ORIGINATION FORM

Proposed Revisions to a Standard Plans Index
(Please provide all information — Incomplete forms will be returned)

Index Number: 455-112

Index Title: 12" CFRP & SS Prestressed Concrete Piles

SECTION A-A

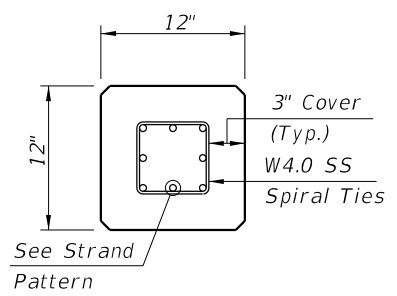
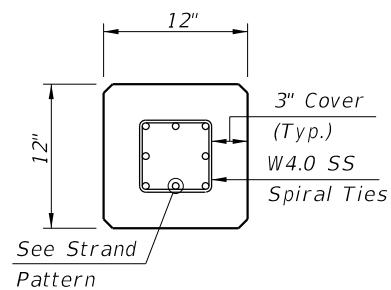
Added 0.6" HSSS strand

STRAND PATTERN
 8 ~ 1/2" Ø, HSSS at 24 kips
 8~0.6" Ø HSSS at 26 kips

- 8 ~ 1/2" Ø, HSSS at 24 kips
- 8 ~ 0.6" Ø, HSSS at 26 kips
